**UBWR Revised Responses to Comments of the  
U.S. Bureau of Land Management and National Park Service on  
the Lake Powell Pipeline Final License Application Documents  
(January 17, 2019)**

Revised Responses to  
U.S. Bureau of Land Management Comments  
On the Lake Powell Pipeline  
Final License Application Documents  
January 17, 2019

Revised Responses to  
National Park Service Comments  
On the Lake Powell Pipeline  
Final License Application Documents  
January 17, 2019

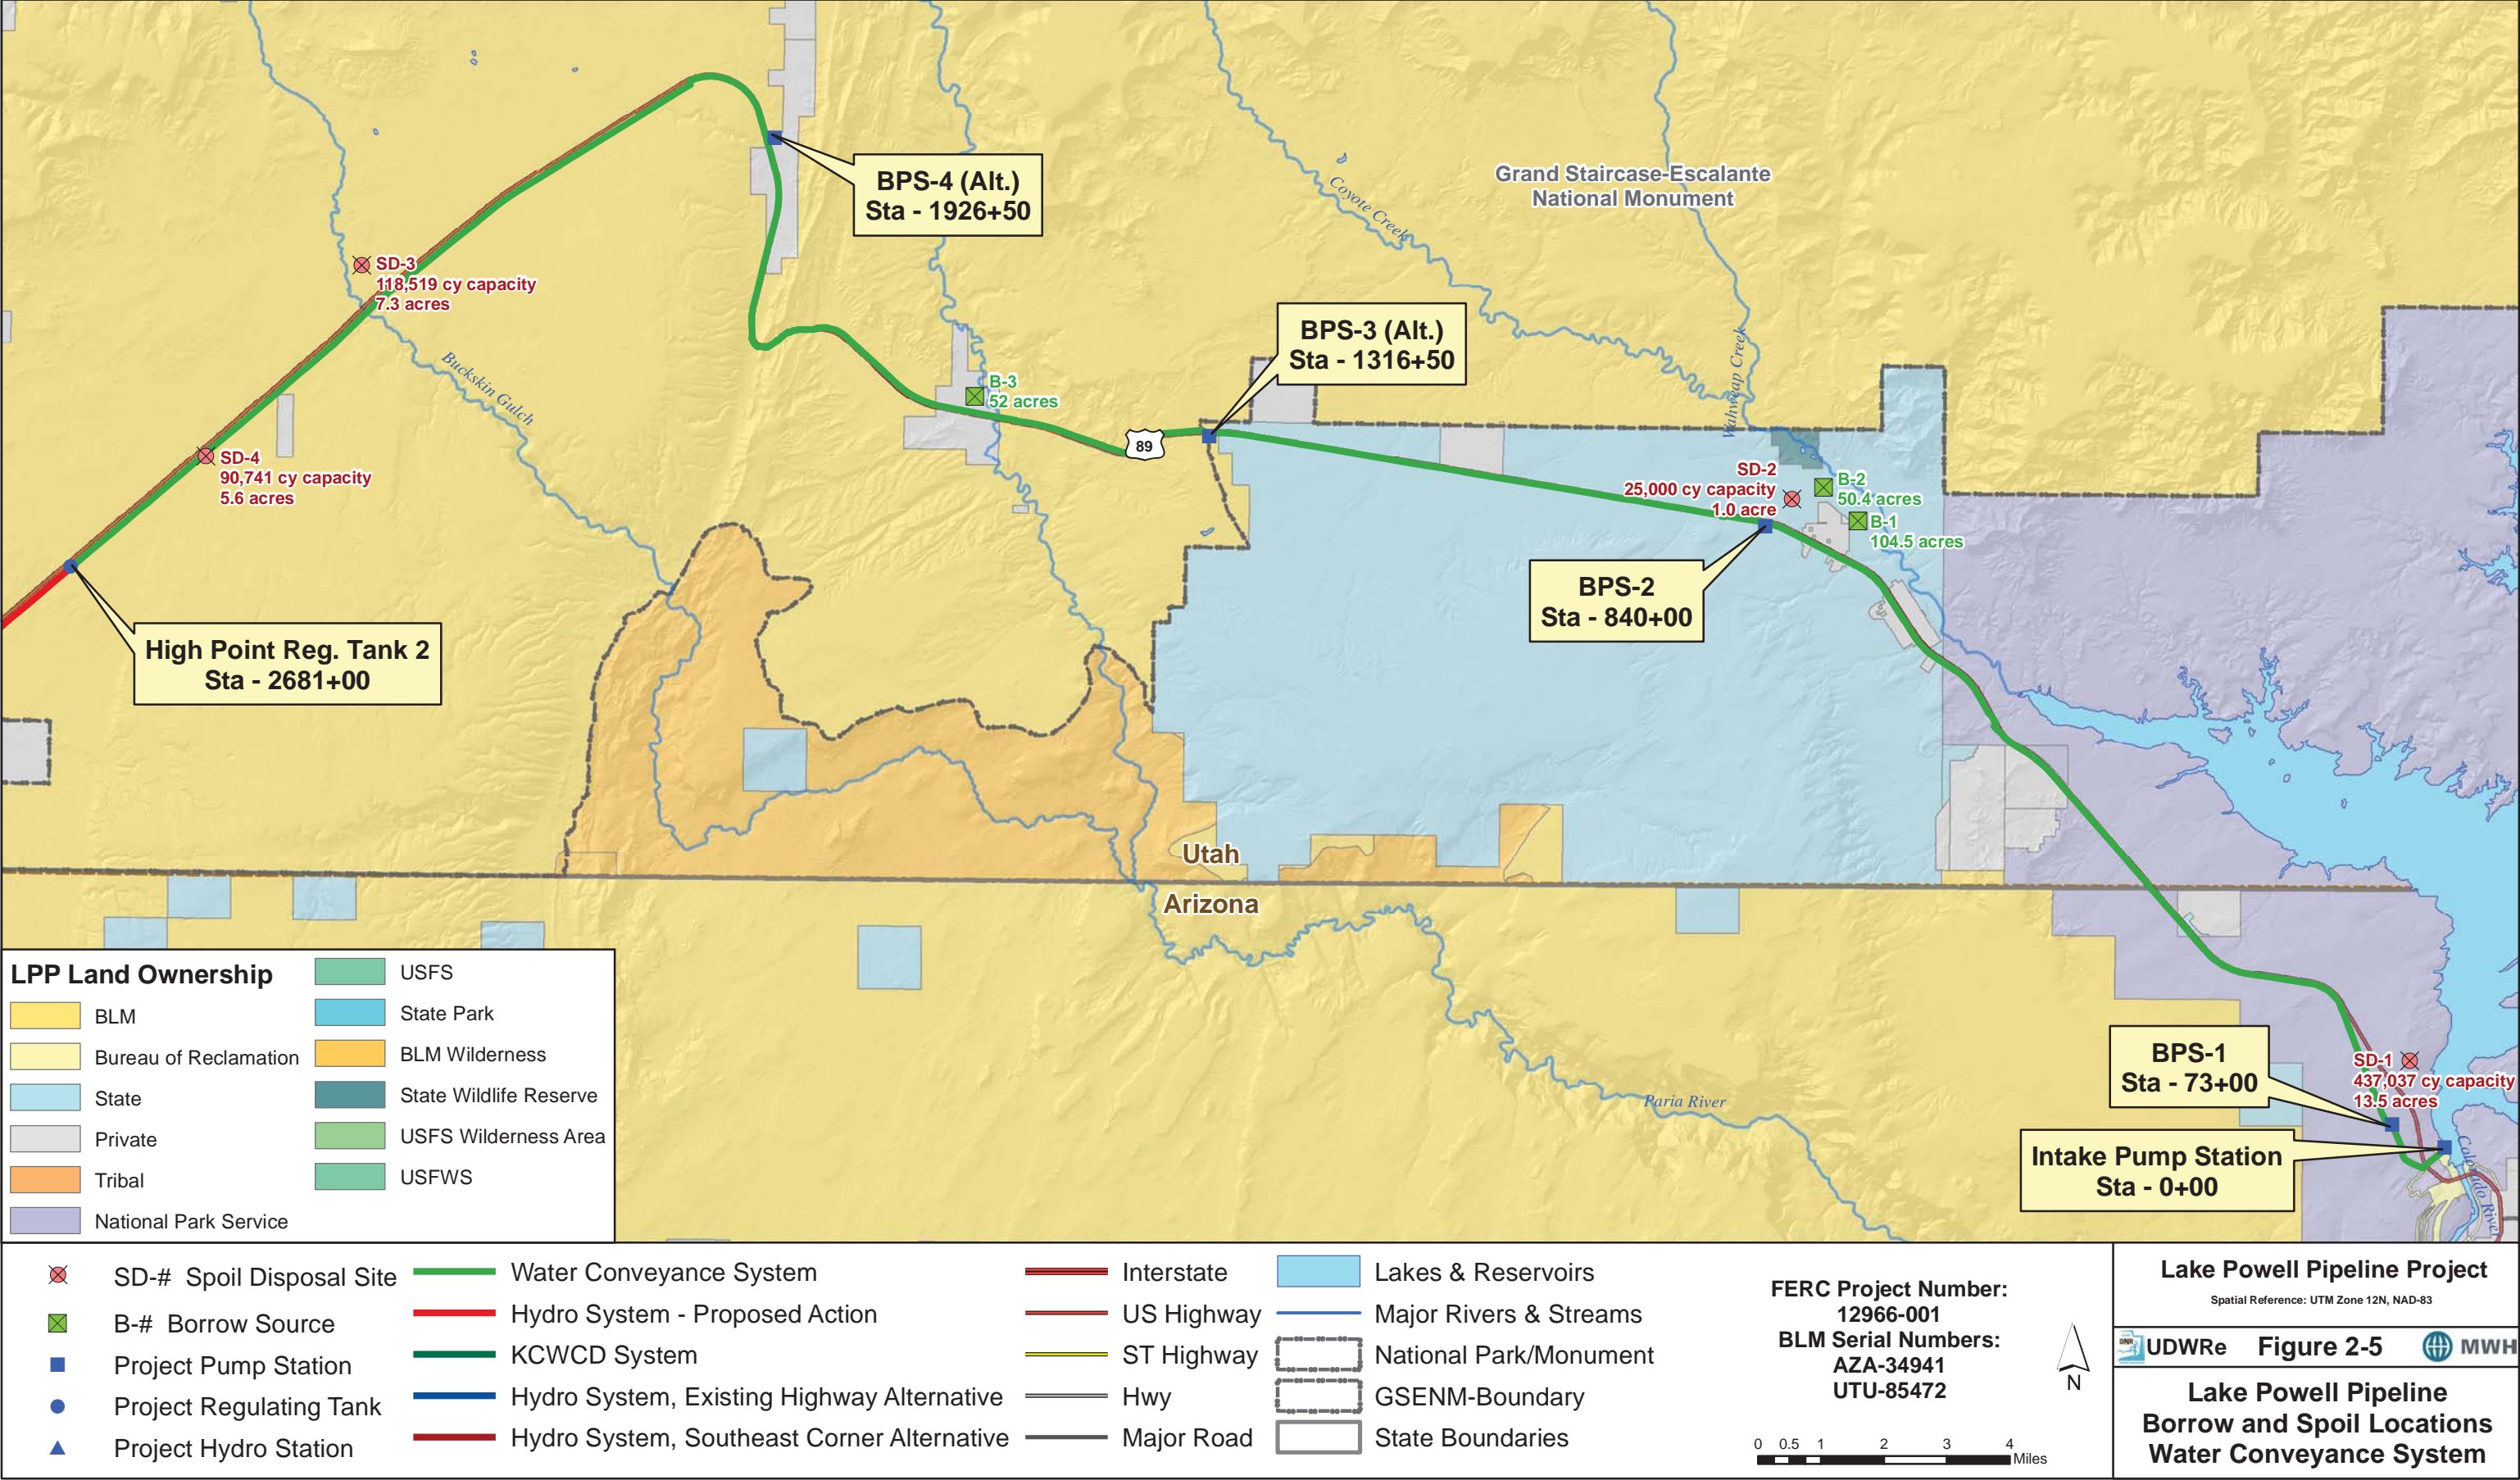
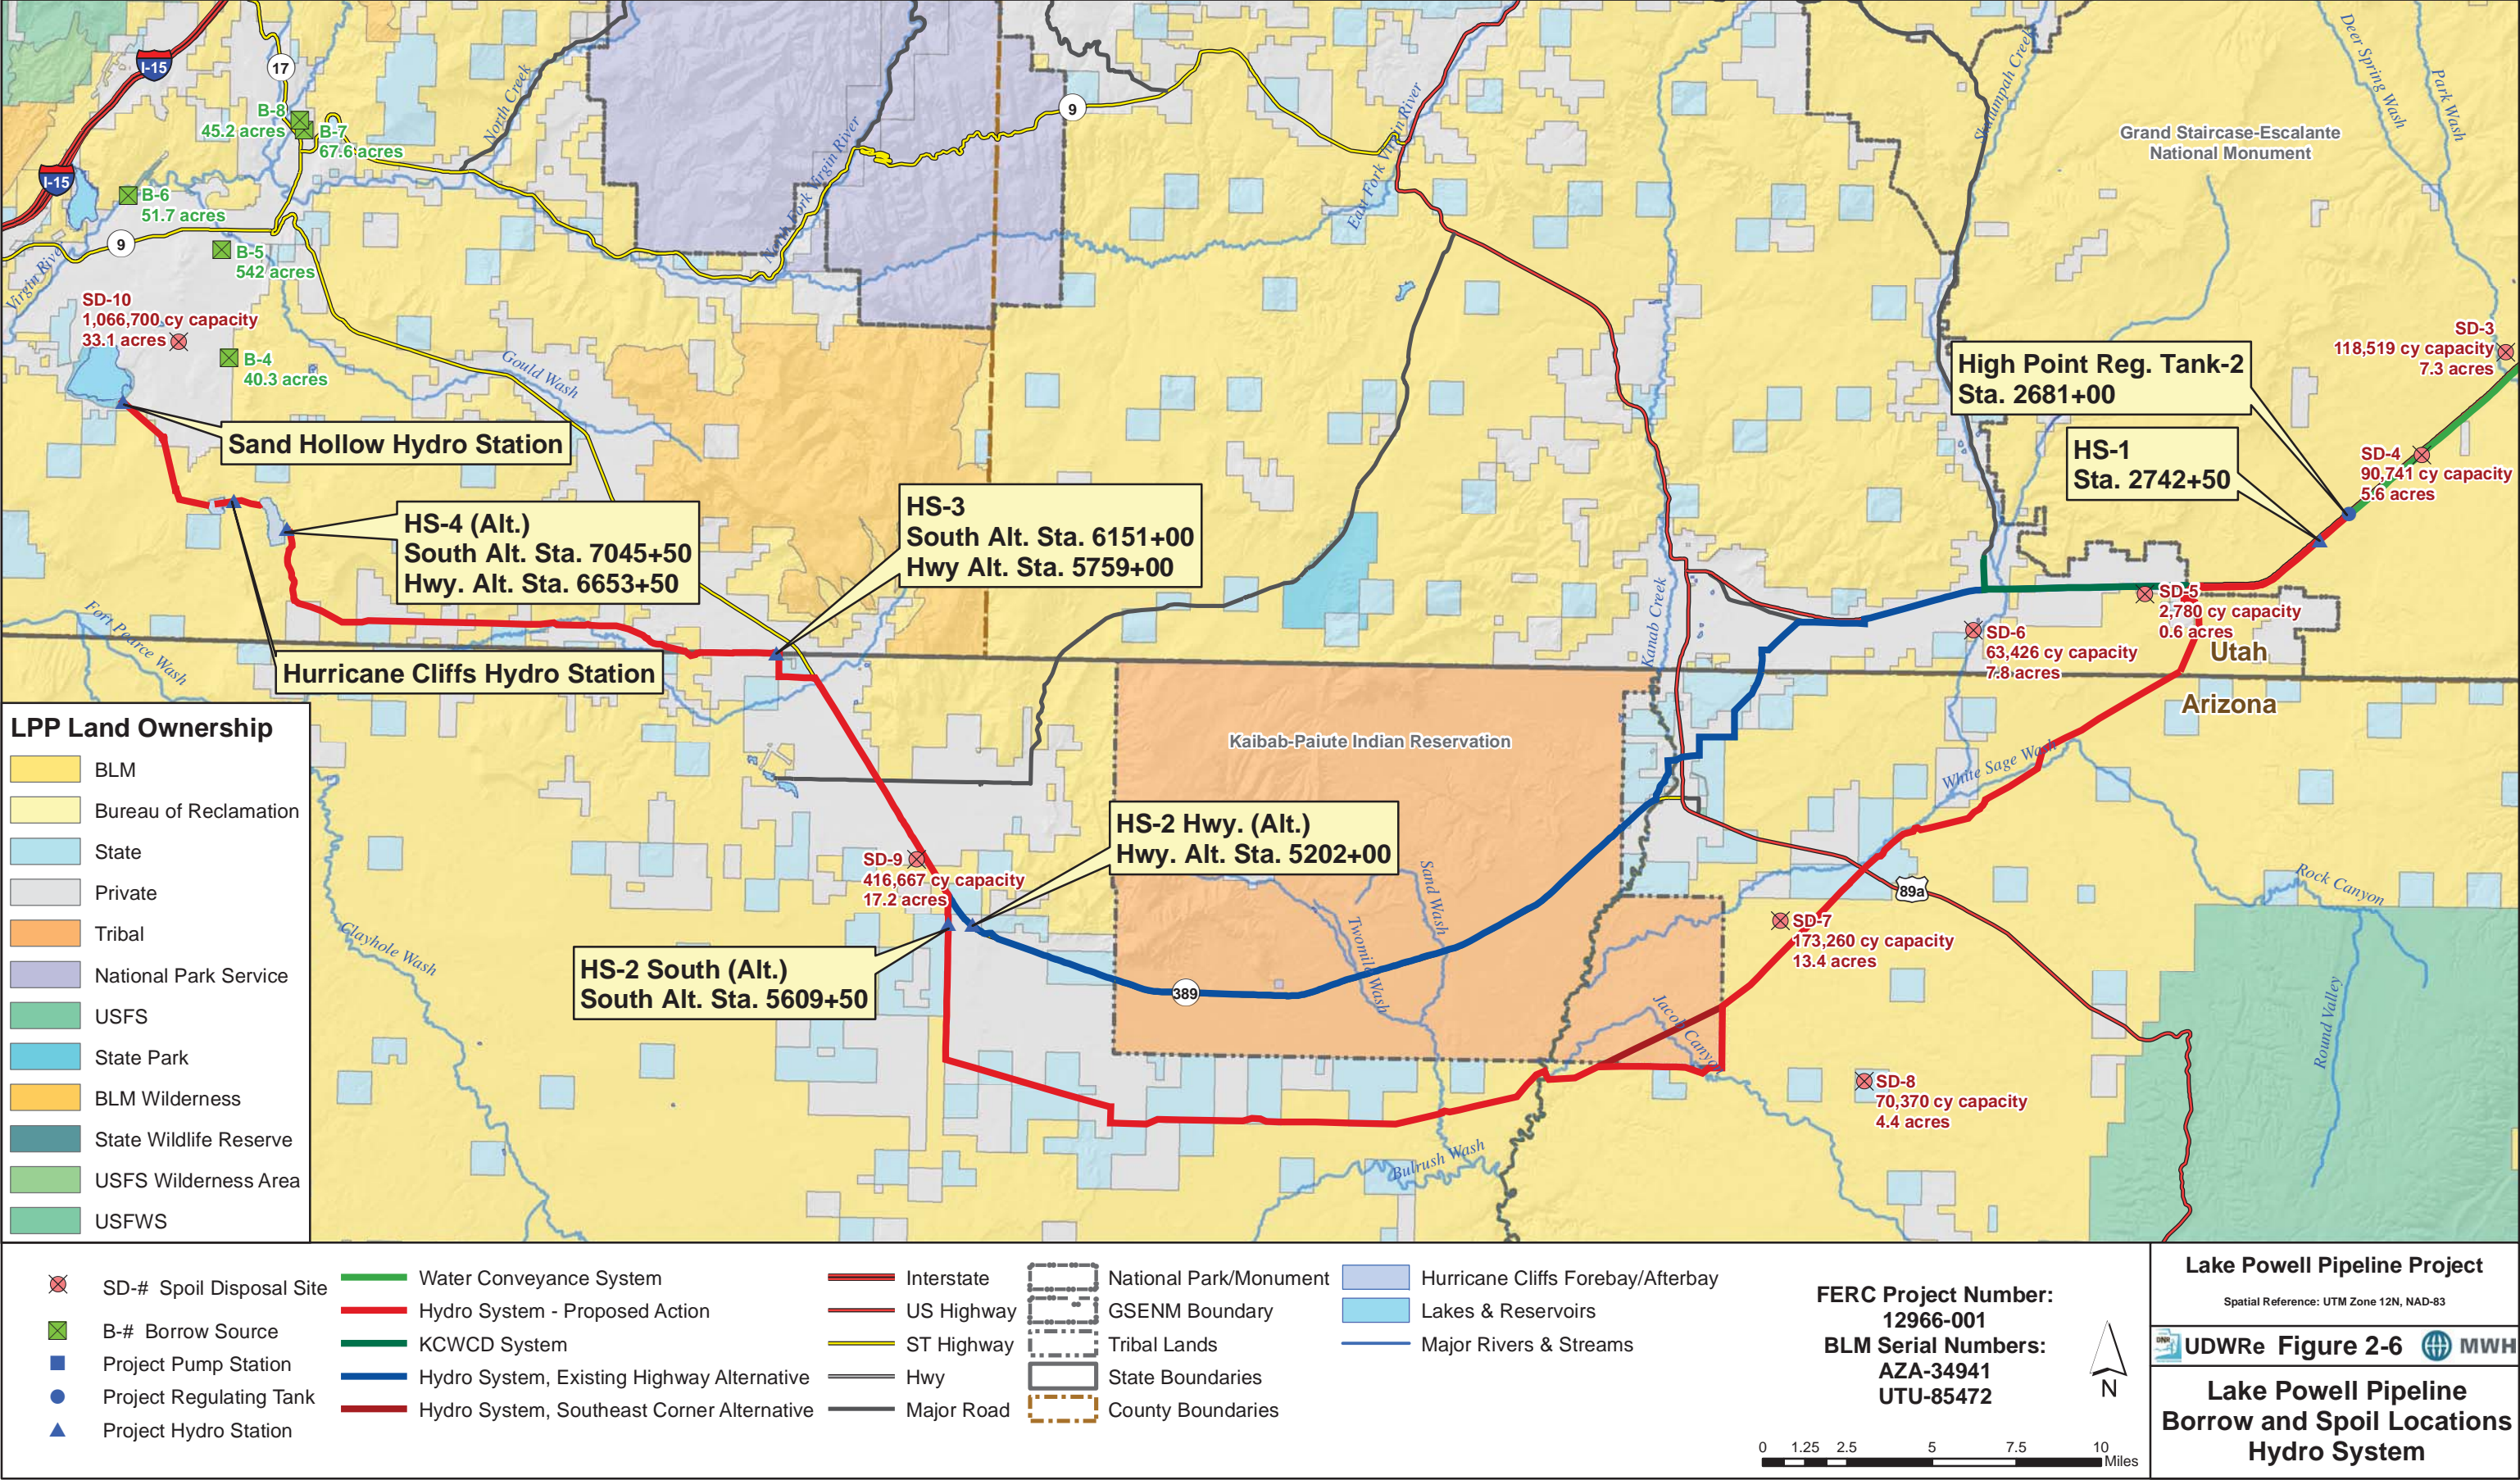
The second paragraph in Section 5.3.1.2.4.7 is revised to read: **The volumes of material generated (neat lines excluding expansion) in cubic yards are summarized below:**

• Blastable	732,800
• Rippable	1,655,300
• Mixed Soil over Blastable	452,400 (293,600 soil – 158,800 rock)
• Mixed Soil over Rippable	599,700 (389,200 soil – 210,500 rock)
• Excavatable	2,696,400

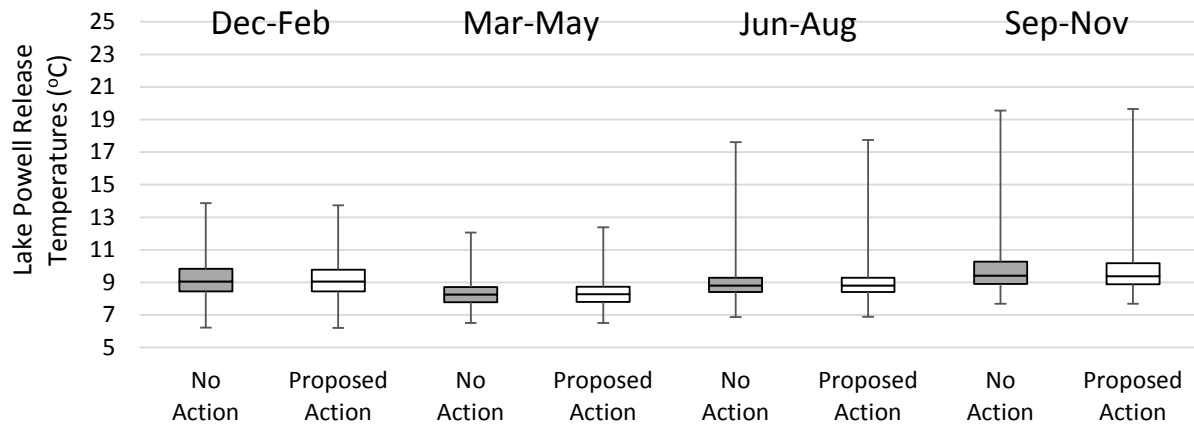
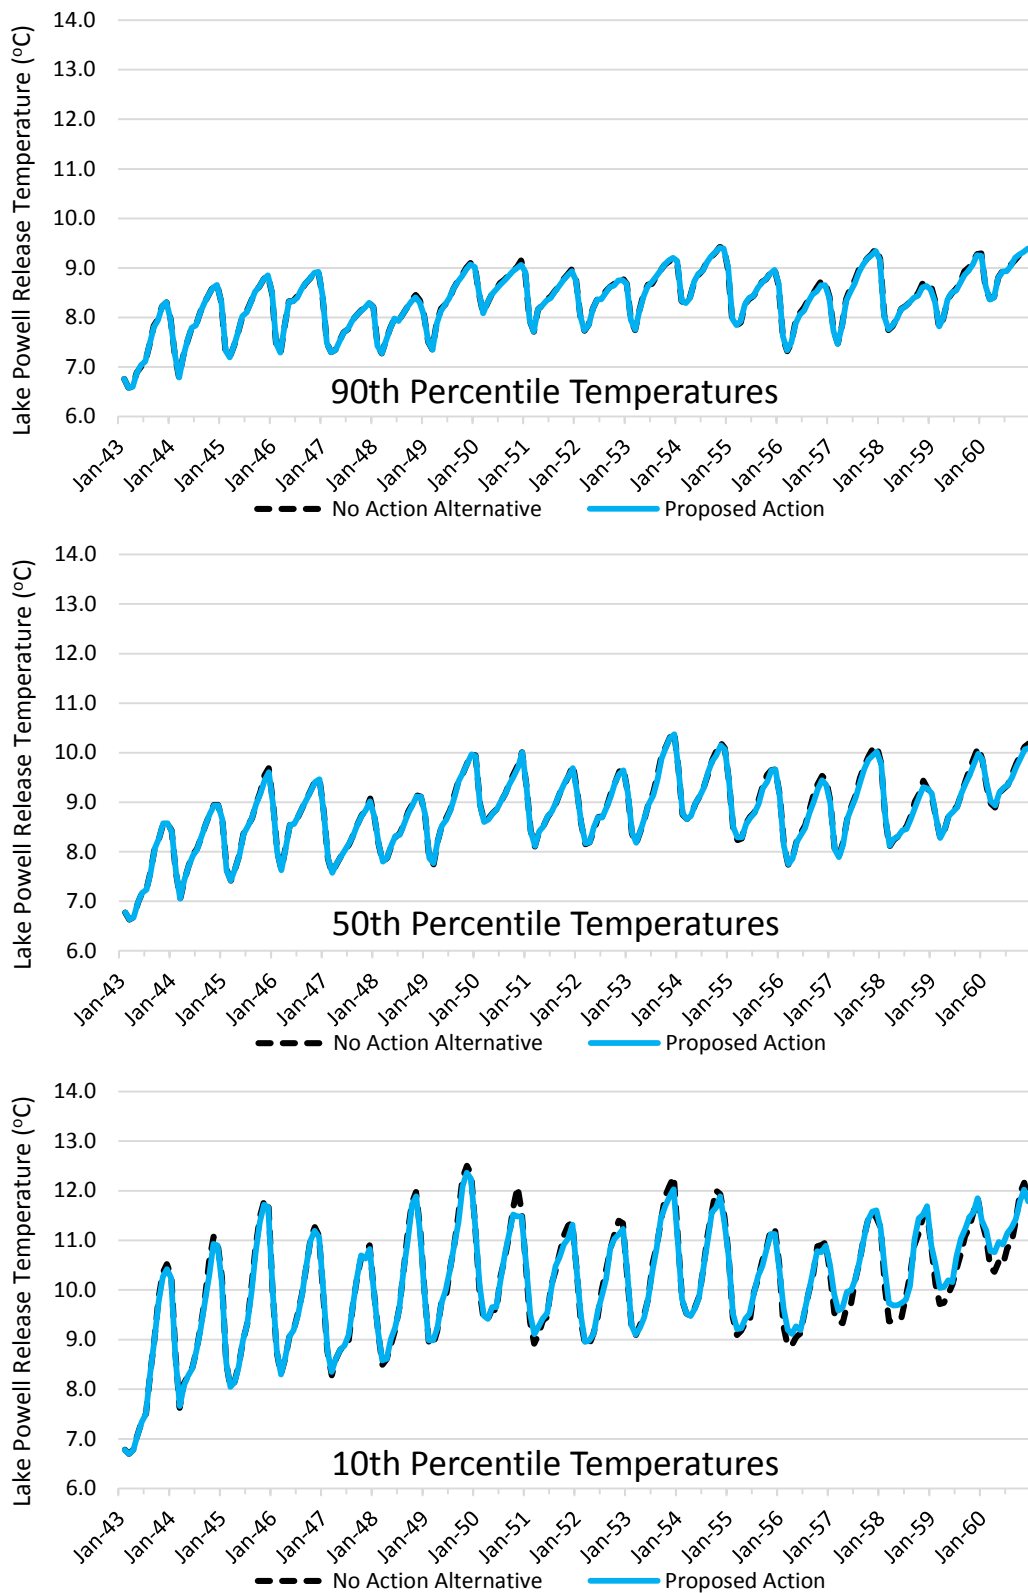
The largest differences between the Proposed Action scenario and the No Action alternative scenario for all 100 traces coincided with drier conditions and lower reservoir pool elevations (see 10<sup>th</sup> percentile temperatures in Figure 5-94B). Temperatures in wetter conditions (50<sup>th</sup> and 90<sup>th</sup> percentiles) are driven more by higher reservoir inflows and elevations, and less by small diversions. On average, the Trace 59 modeled results for the Proposed Action compared with the No Action alternative are within 0.1°C for the 2045-2060 period. For individual years, differences of up to 0.71°C were predicted (Reclamation 2016). For all 100 traces, average temperature changes between the Proposed Action and the No Action Alternative range between -0.1°C and 0.2°C. For individual months, differences range between -1.9°C and 0.5°C.
